SITE PLAN REVIEW COMMITTEE MEETING AGENDA

A. Review and take action: Edge Field Preliminary Plat

B. Review and take action: Hunter Oaks Enclave Preliminary Plat

RE: Edge Field Preliminary CSM Review

PRELIMINARY PLAT OF
EDGE FIELD

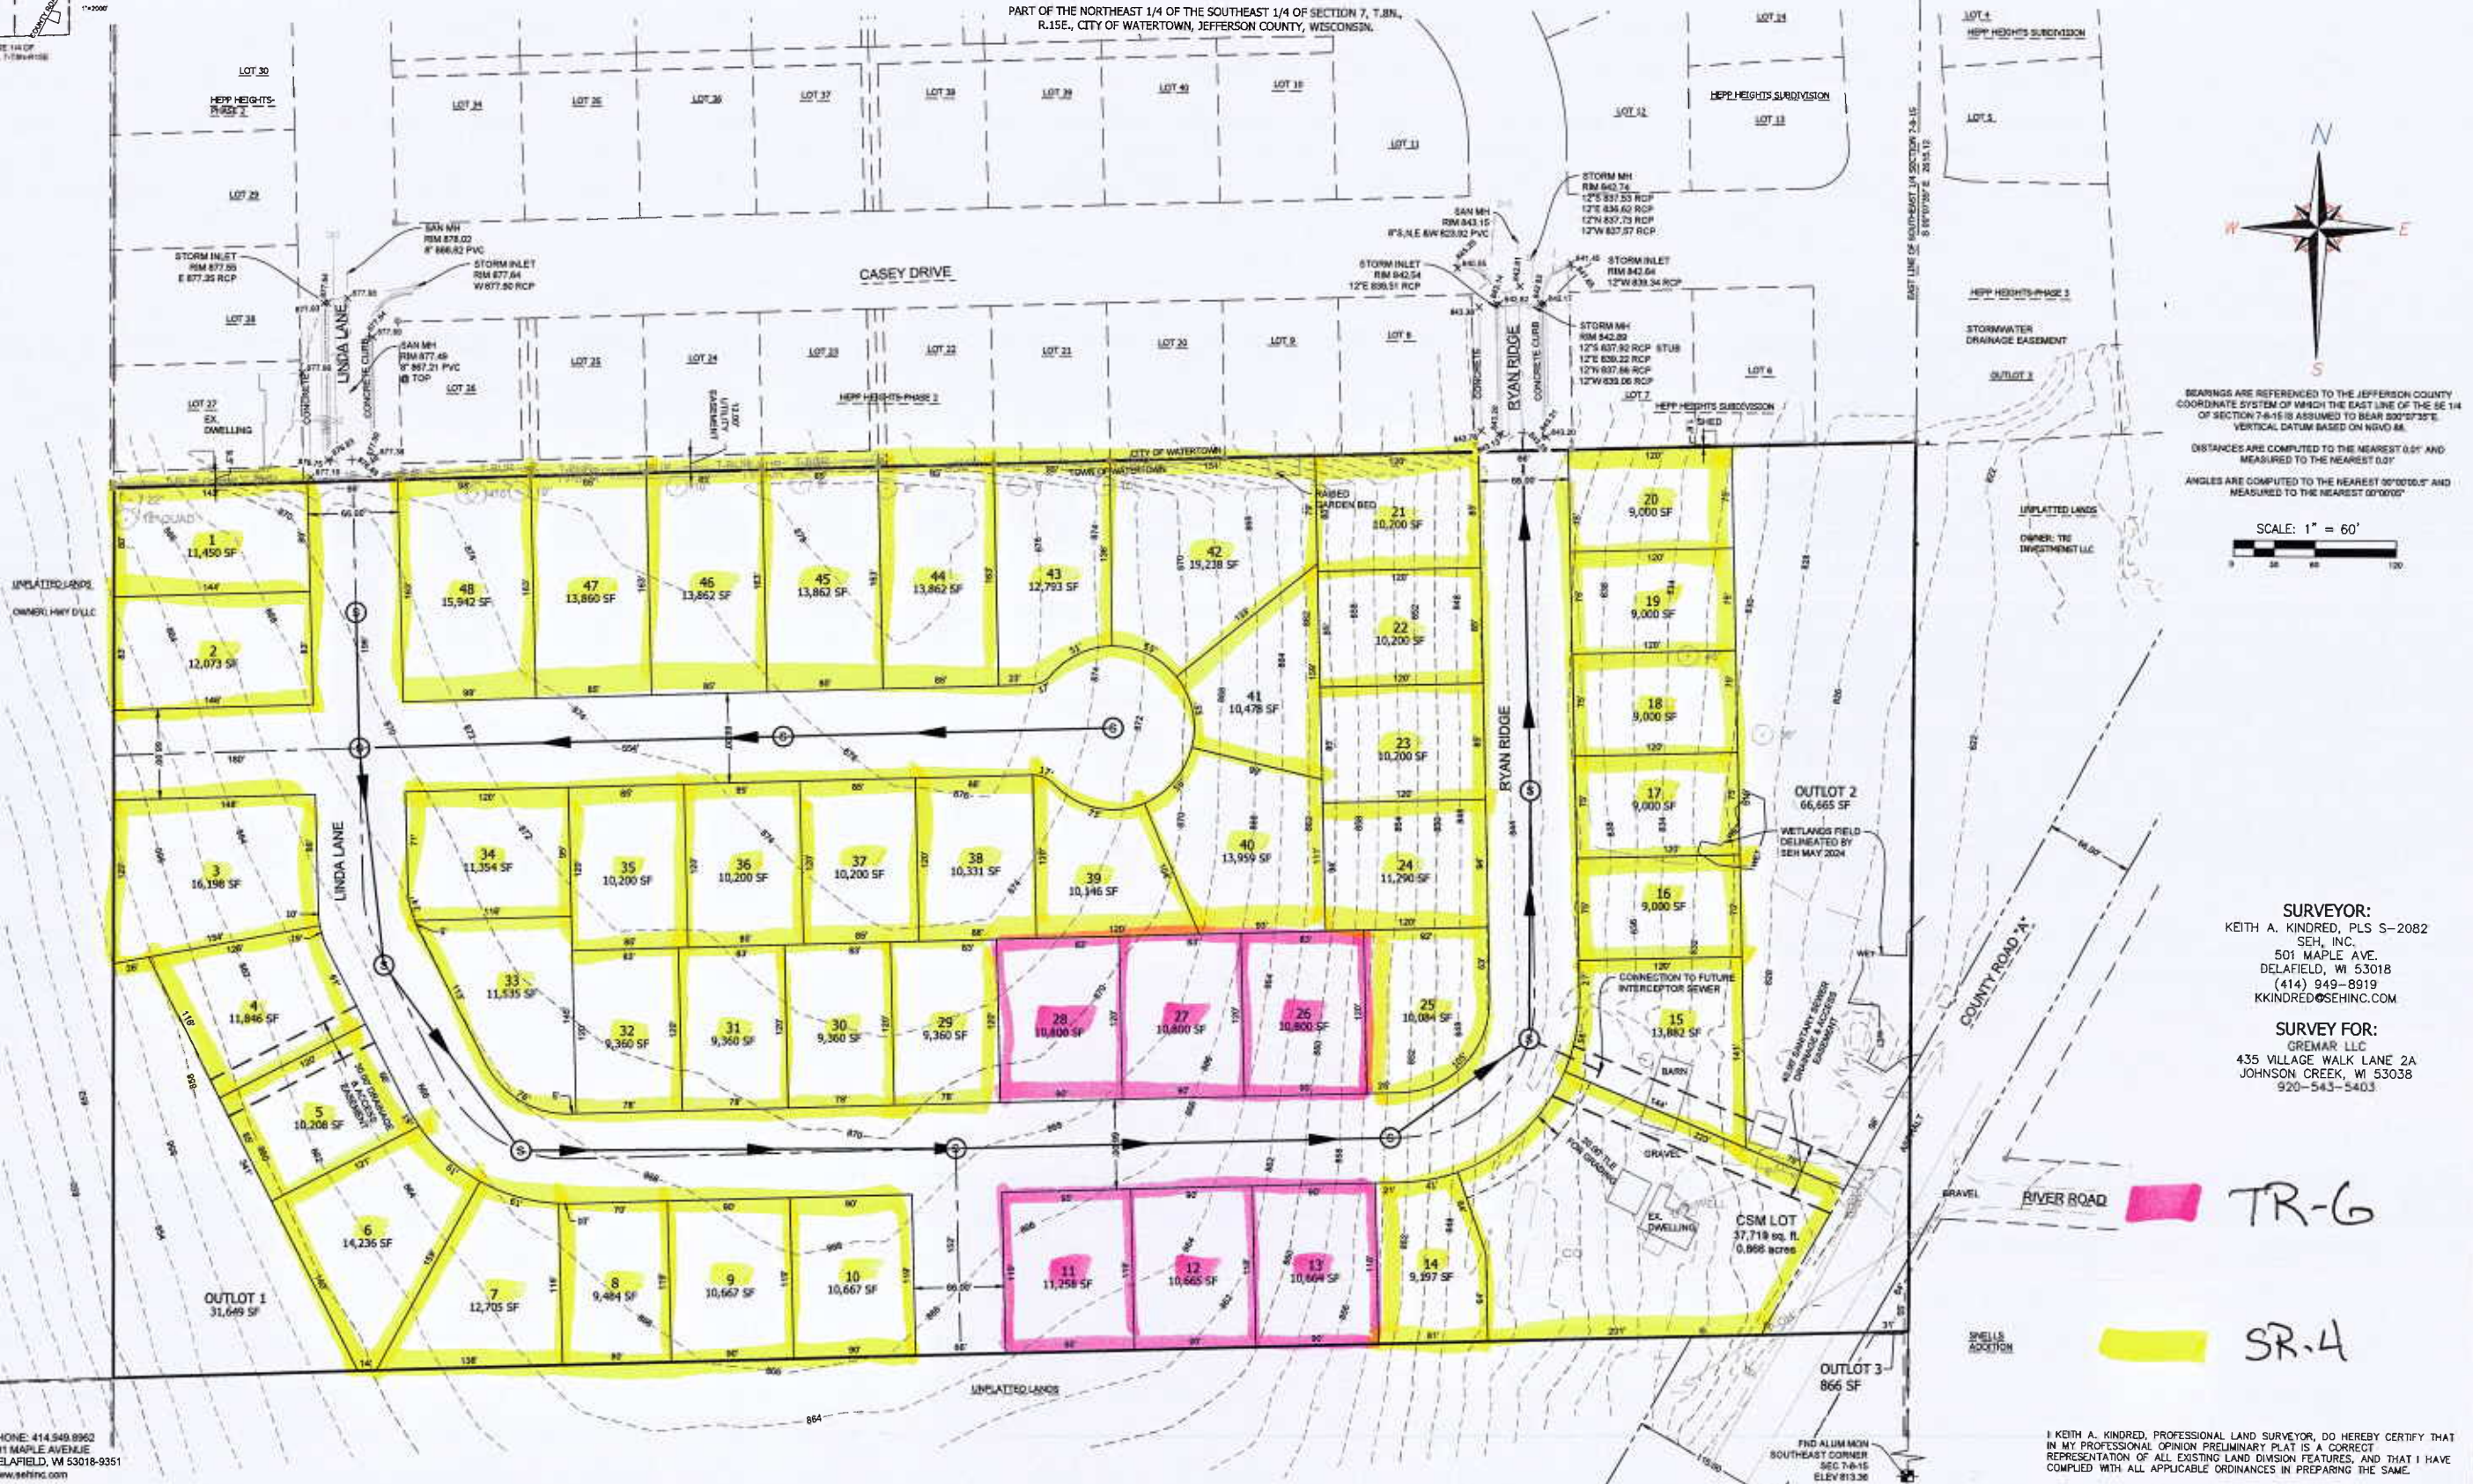
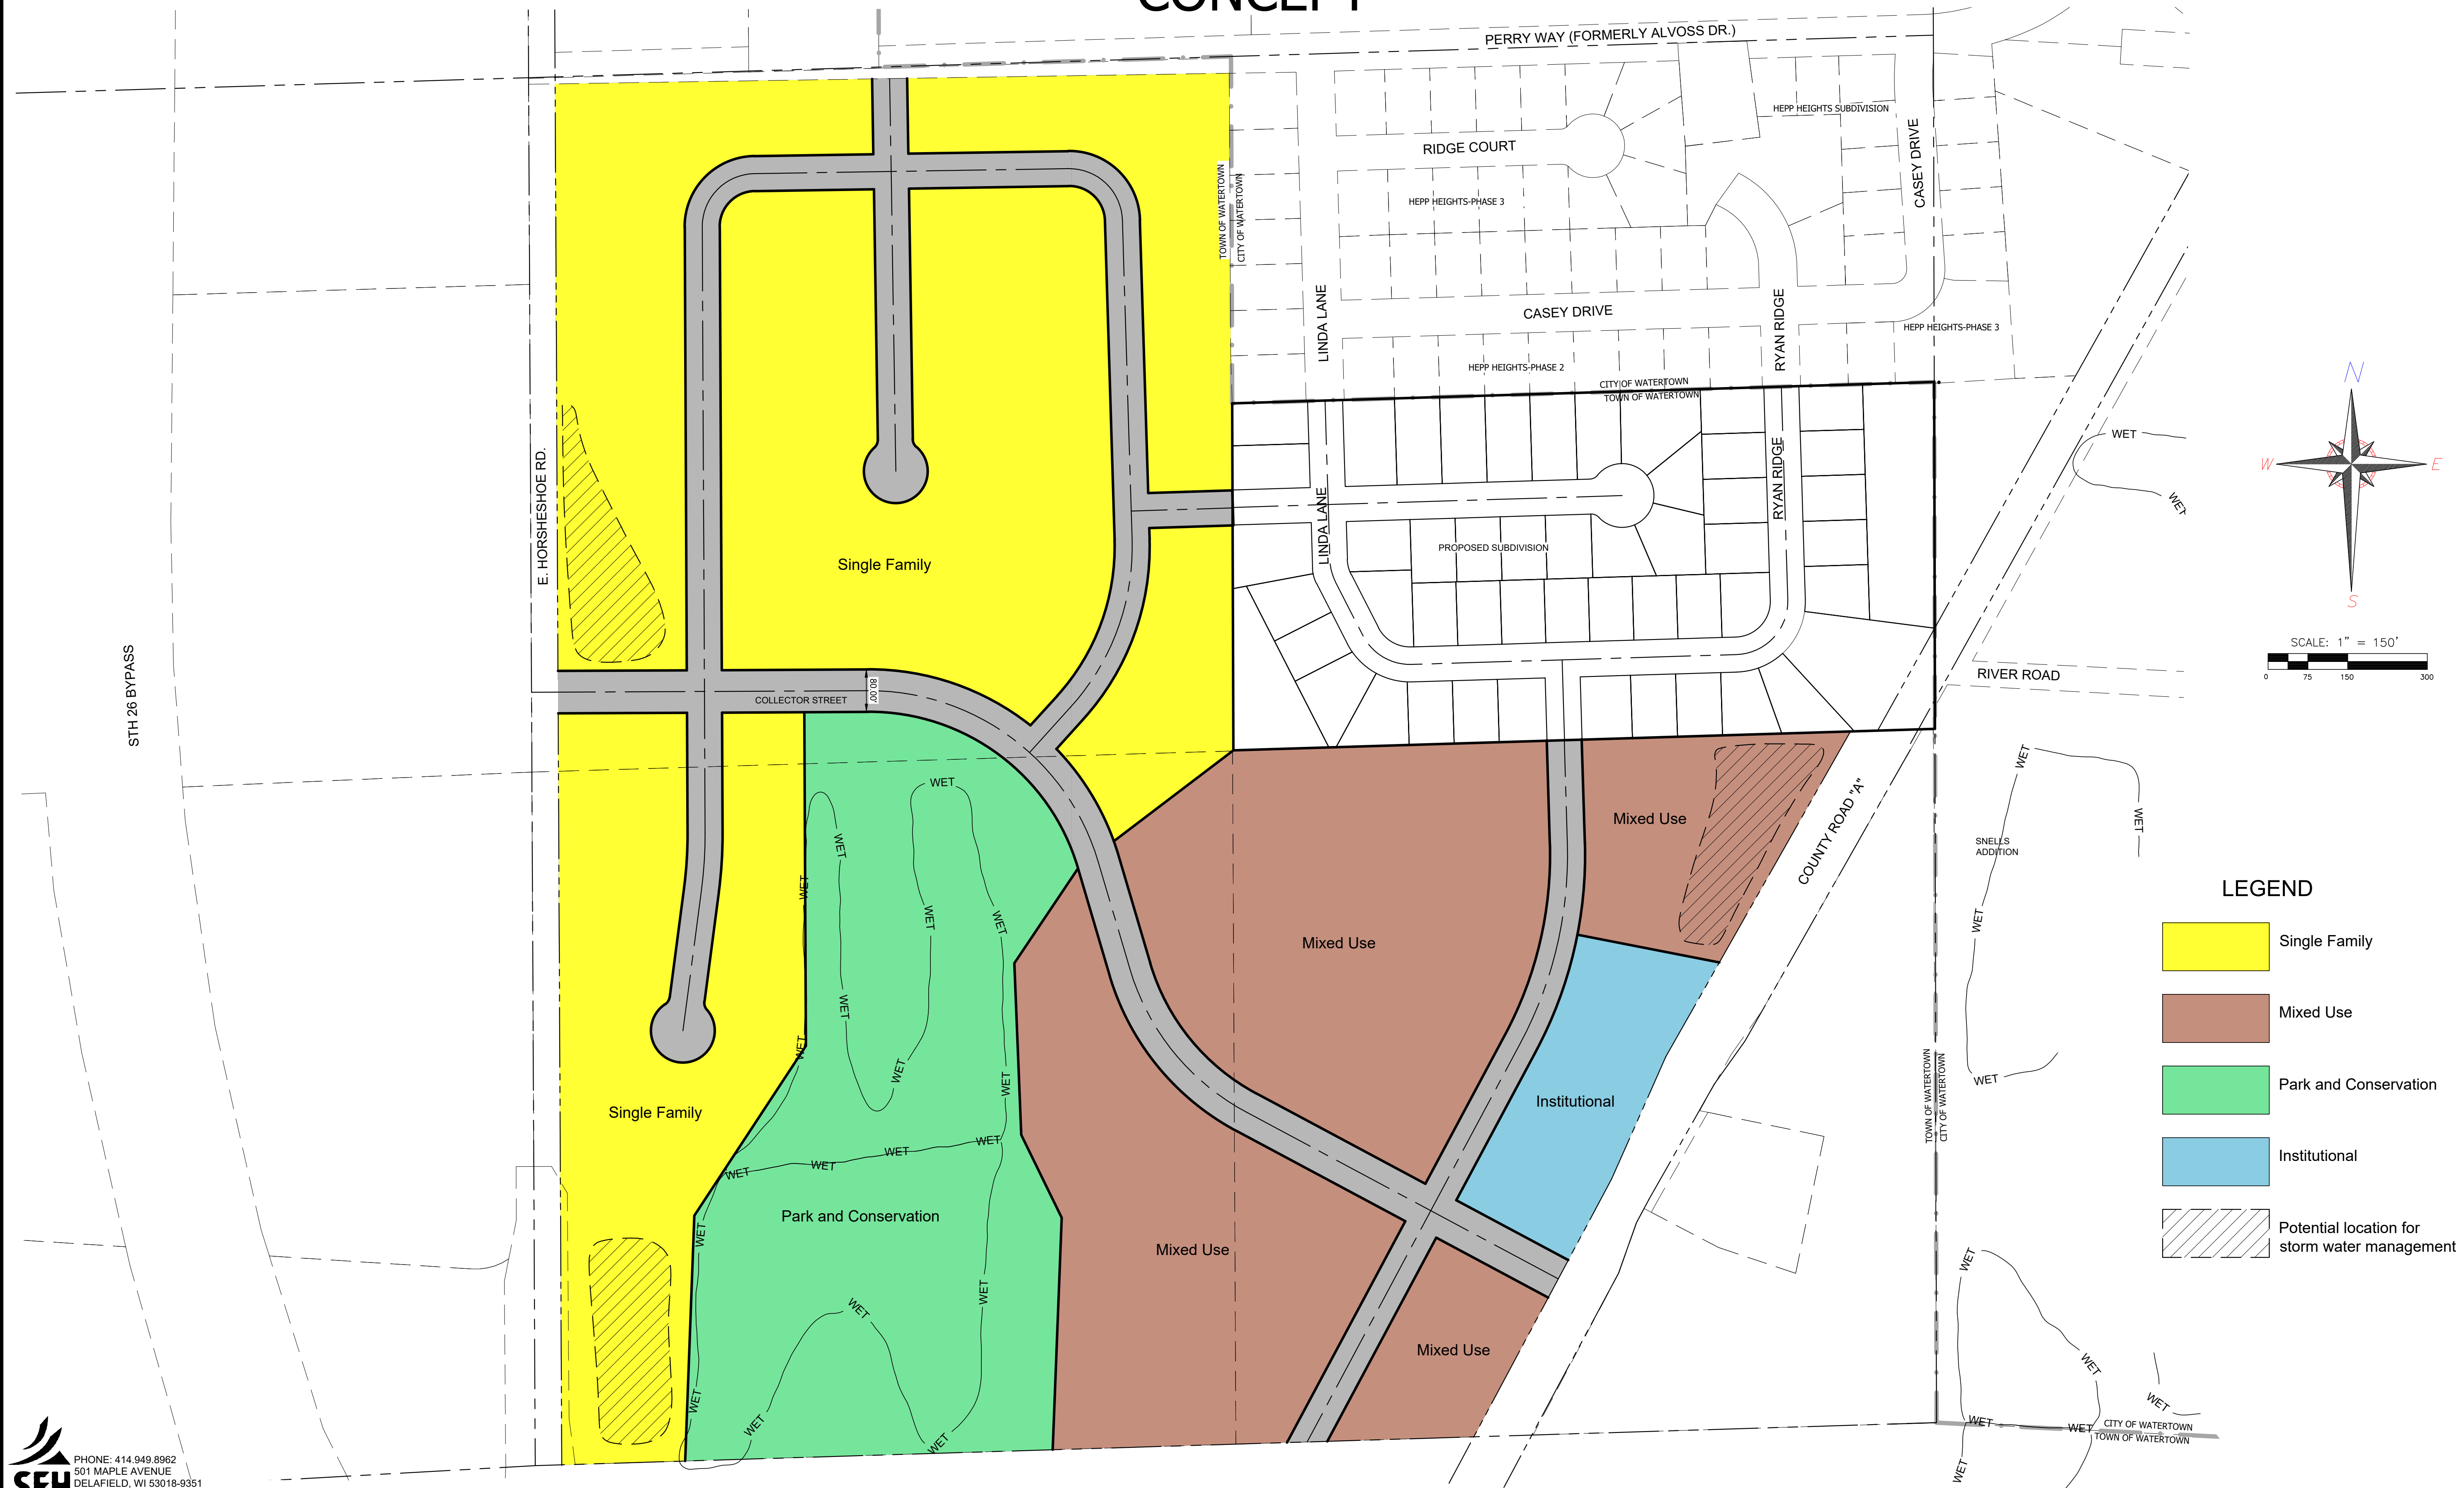
The County Surveyor and I have reviewed the preliminary CSM for Edge Field, prepared by Keith Kindred, PLS, job no. 178692, as dated October 15, 2024, and have the following comments:

- label the radii of the curves
- label the City/Town corporate limits
- Include a road name for the east/west cul-du-sac road and the southernmost road stub

For the final plat, any stormwater outlots (outlot 1 and 2) a note will need to be placed on the plat stating that all lots have an undivided interest in the outlots. Draft language can be provided if needed.
